**MOORE PUBLIC SCHOOLS -
OLD SCHOOL REPLACEMENT**

ADDENDUM NO. 1

April 2, 2026

A109

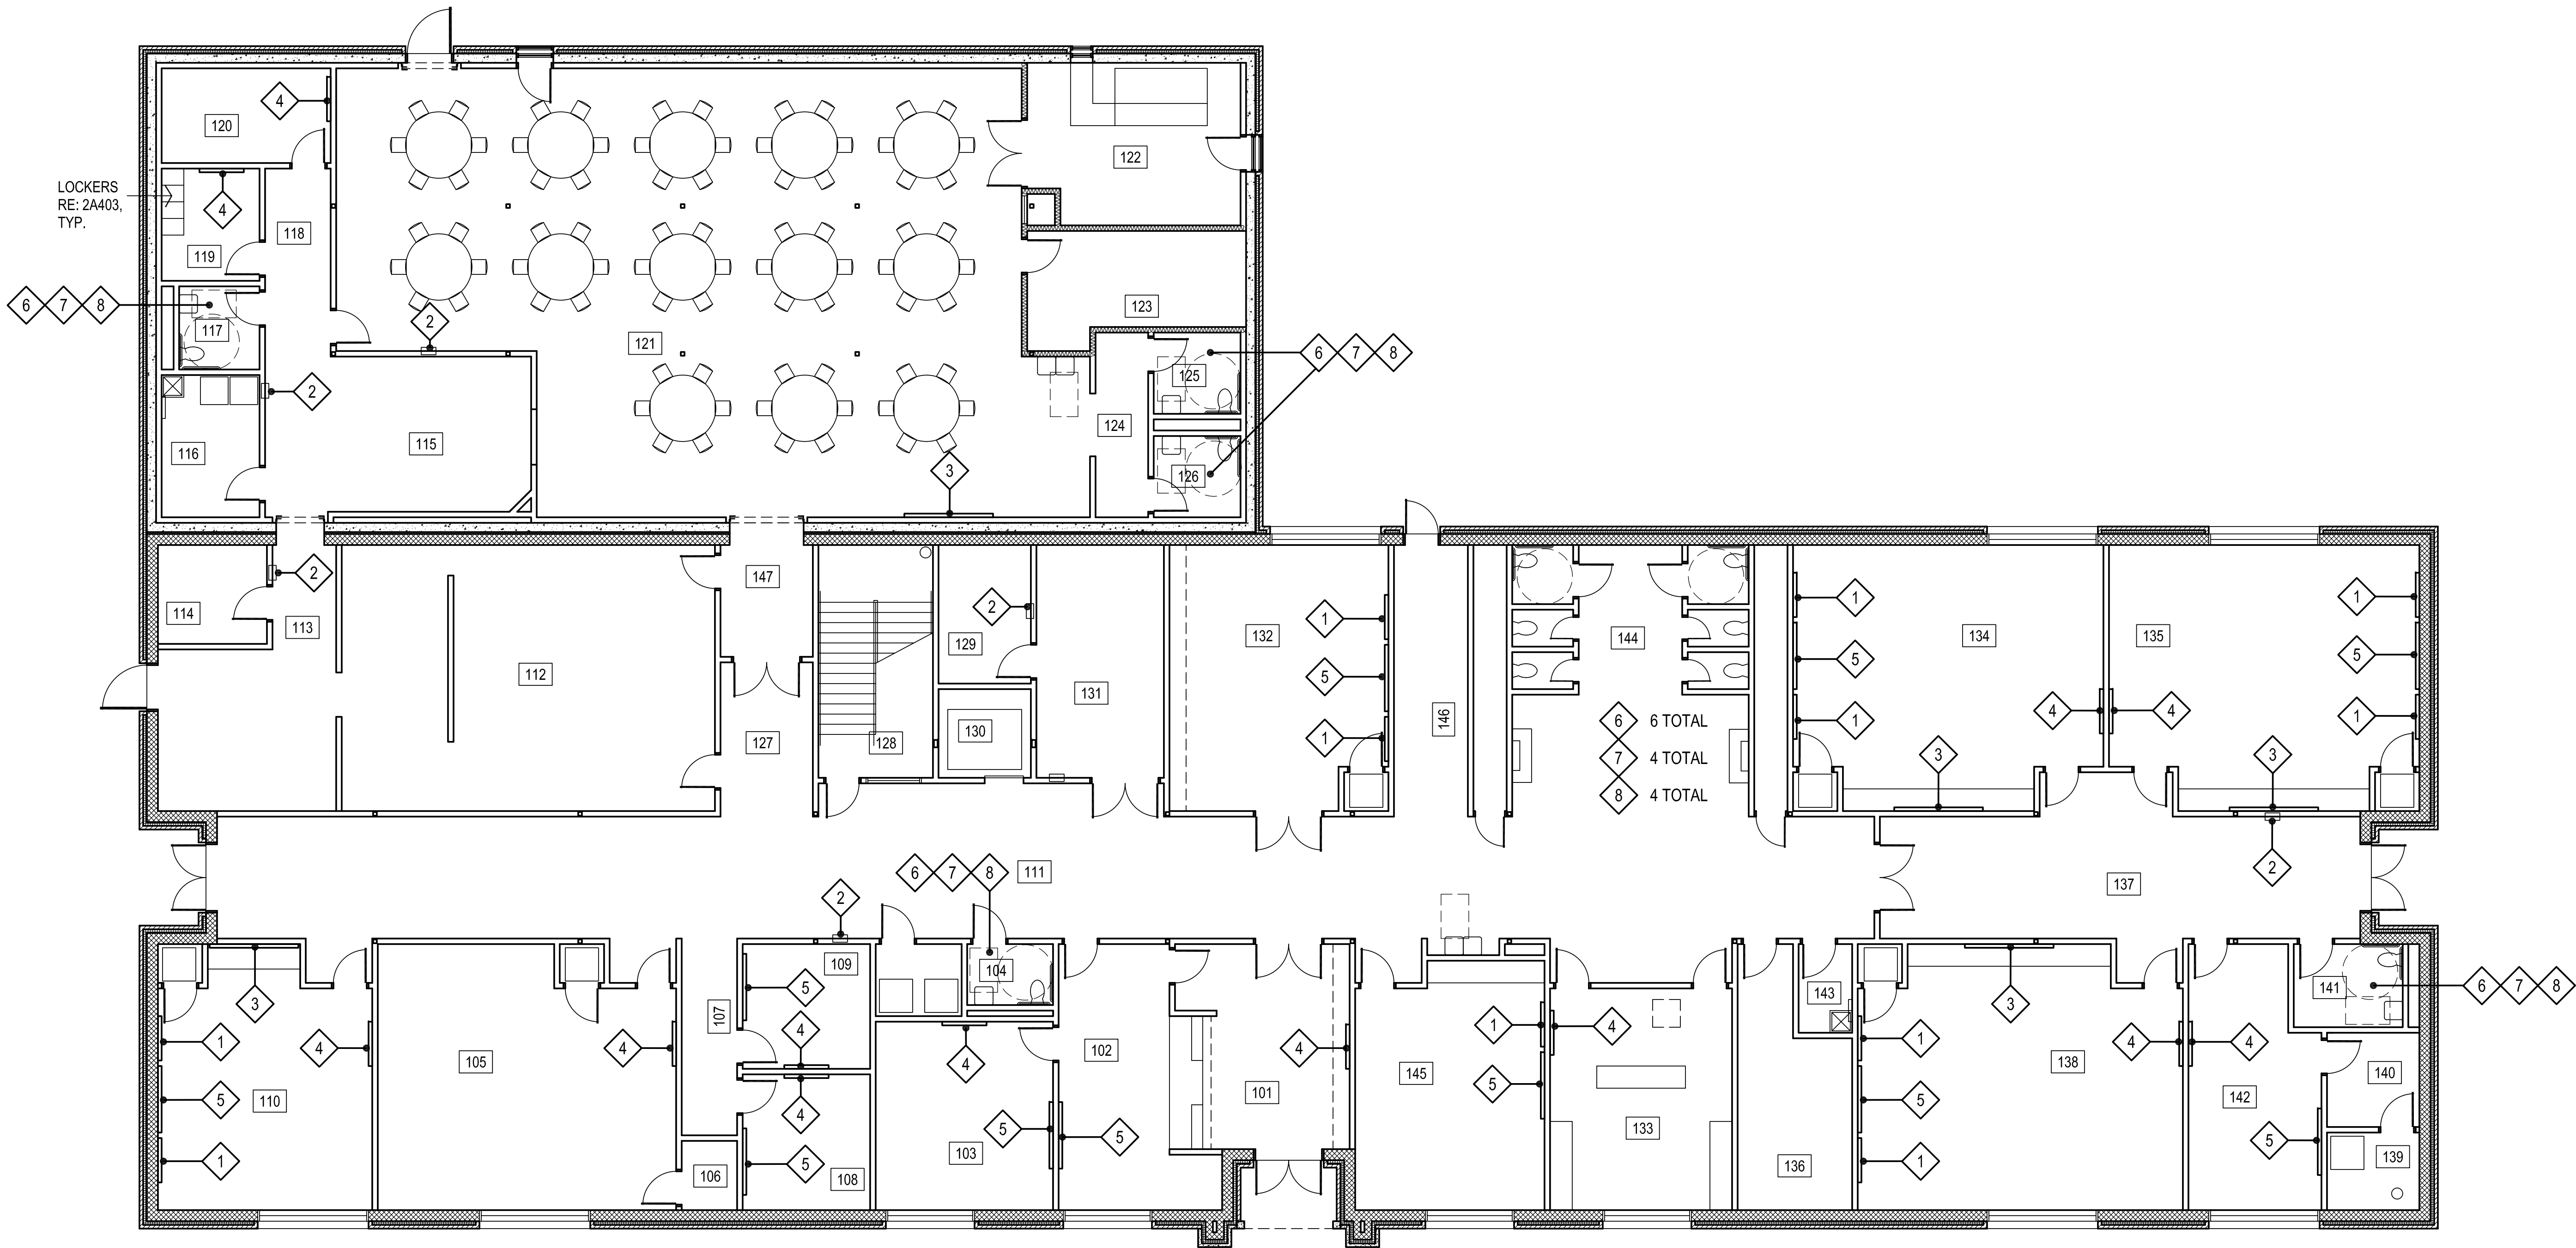
6. Sheet A107, Detail #3, South Wall Room #101: revised vertical detail reference number as indicated. Refer to attached revised drawing.
7. Sheet A109, Detail #1, First Floor Equipment Plan and Sheet A110, Detail #1, Second Floor Equipment Plan: revise rooms / areas as noted to allow for installation of display / trophy cases. Refer to attached revised drawings.

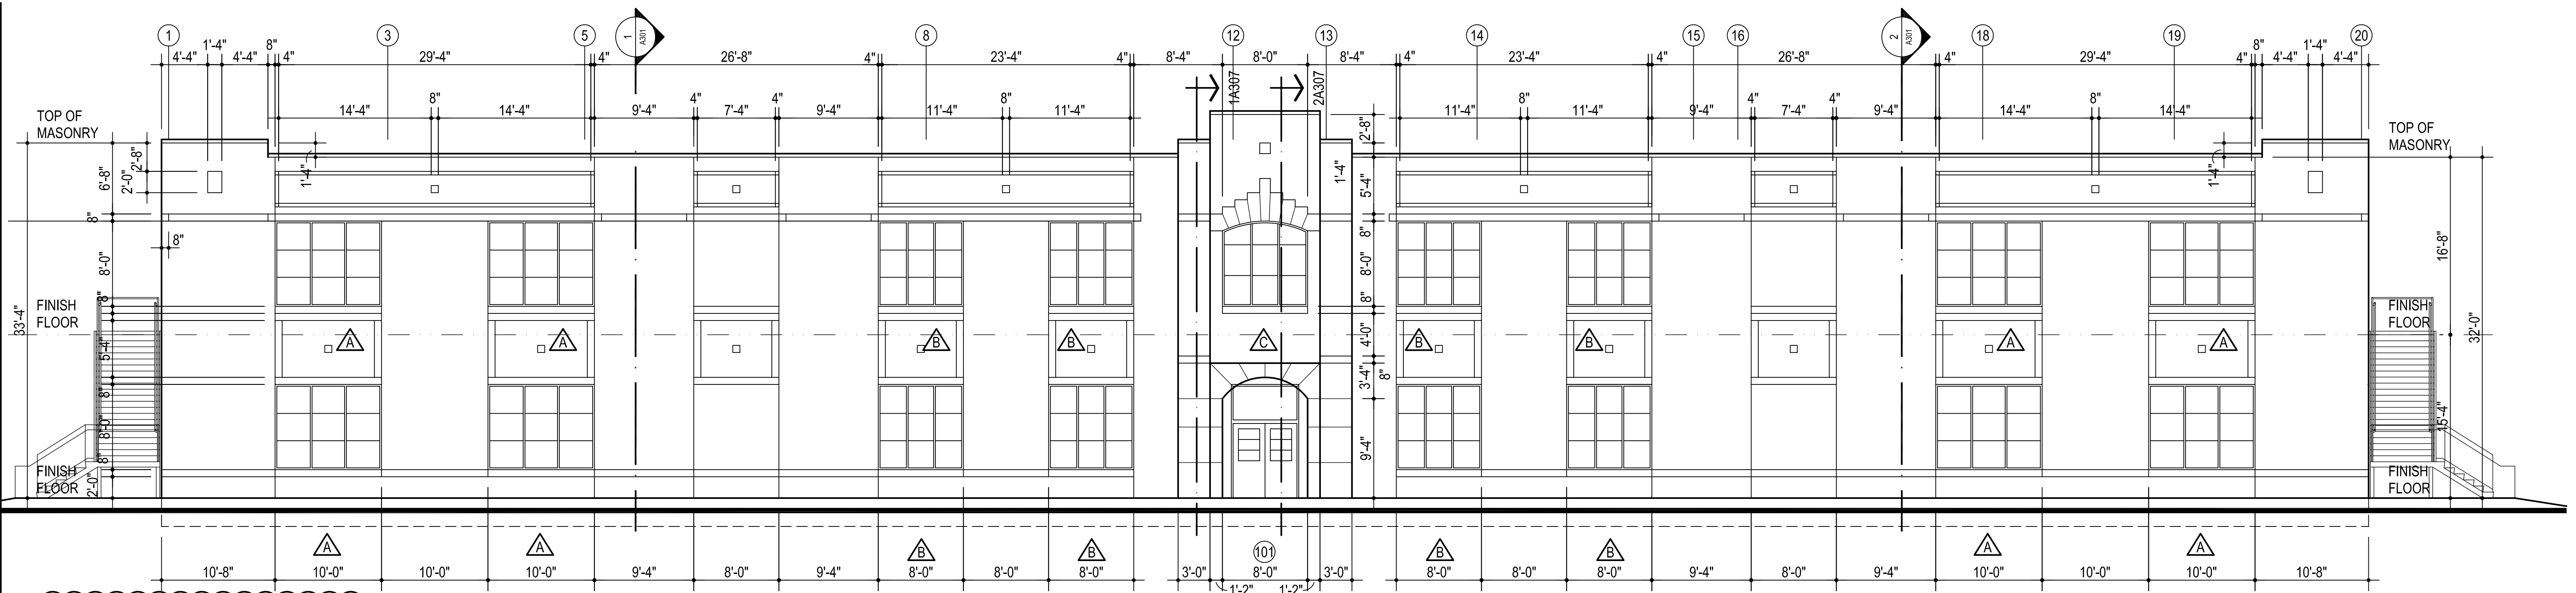
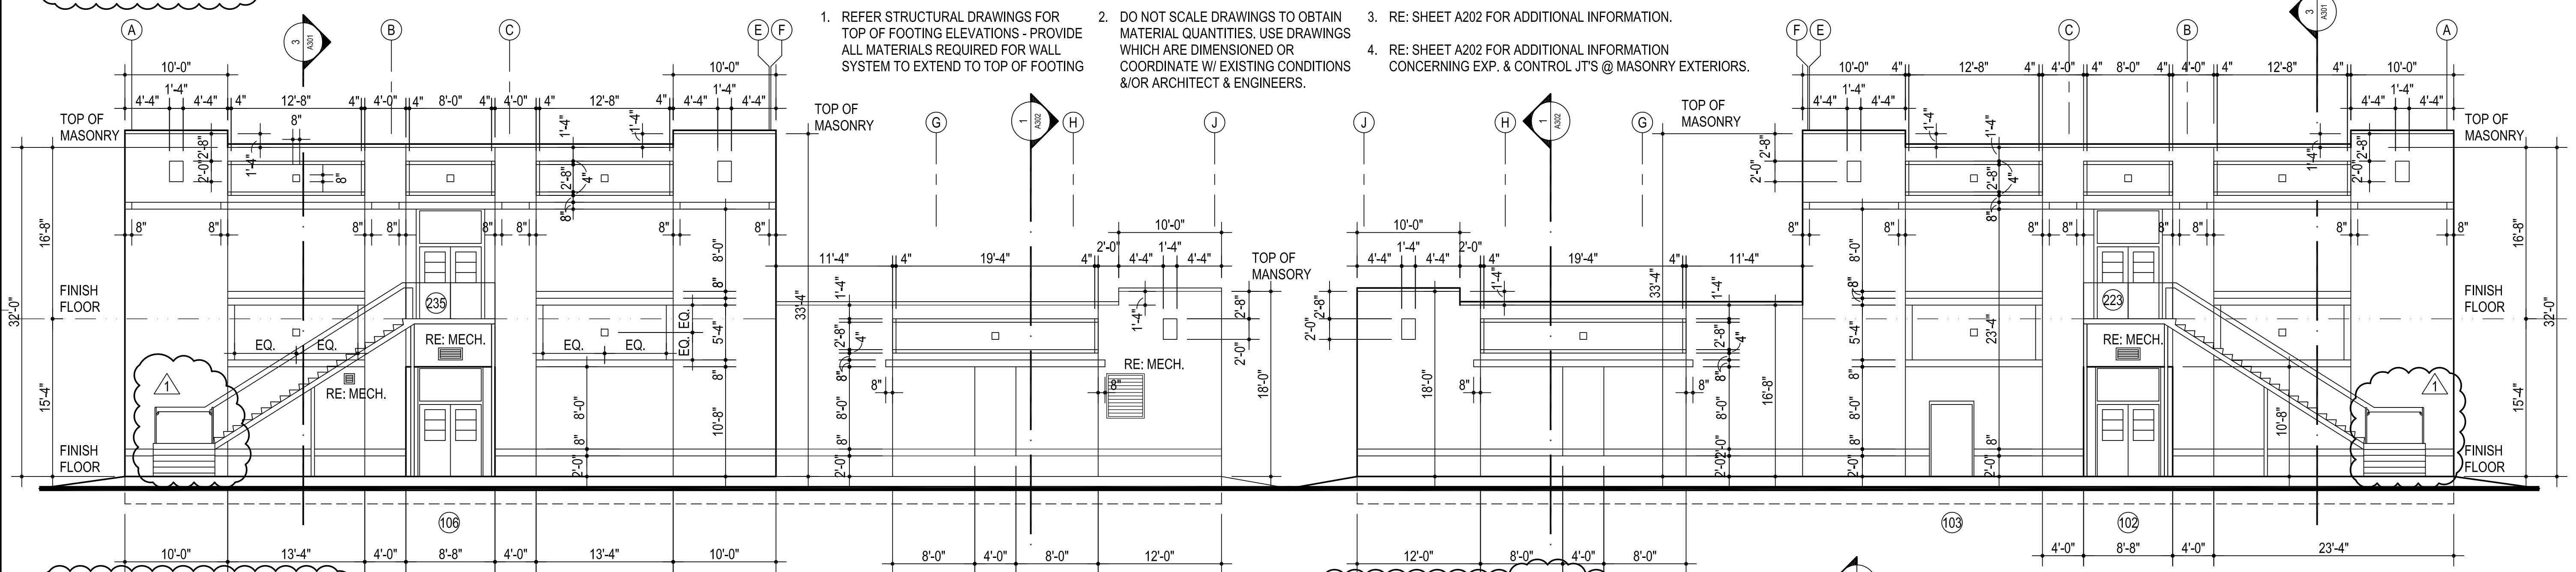
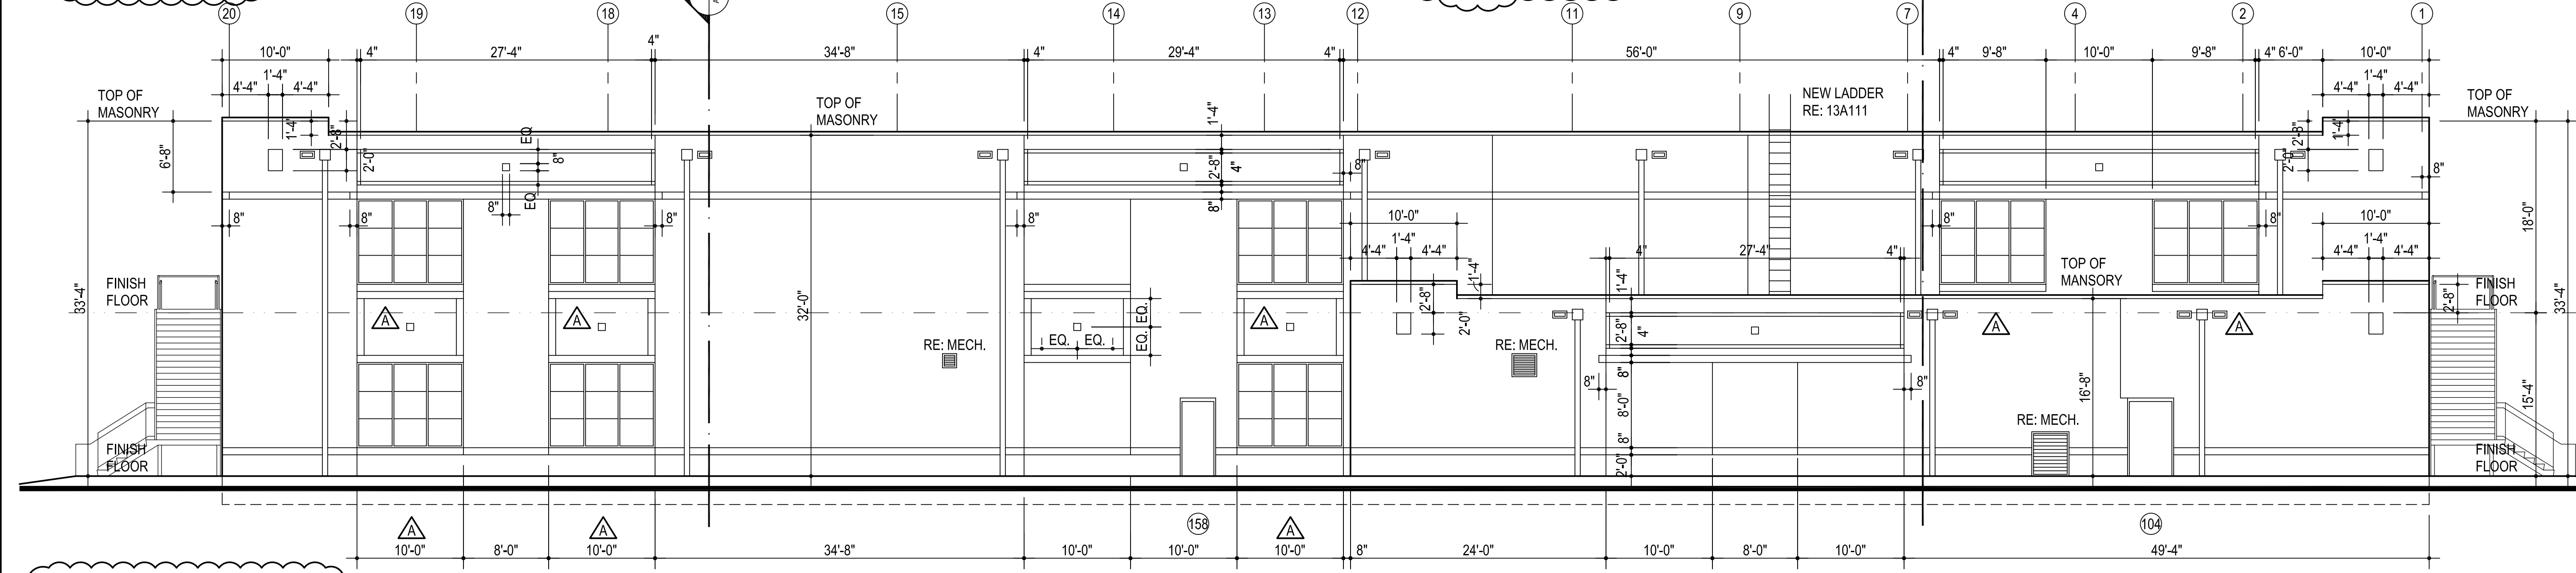
8. Sheet A201, Exterior Elevations / Sheet A202, Exterior Elevations-Materials / Sheet A204, Detail #1, North Elevation / Sheet A301, Detail #3, Building Section: revised exterior elevations / building section to reflect changes to exterior stairs. Refer to attached revised drawings.
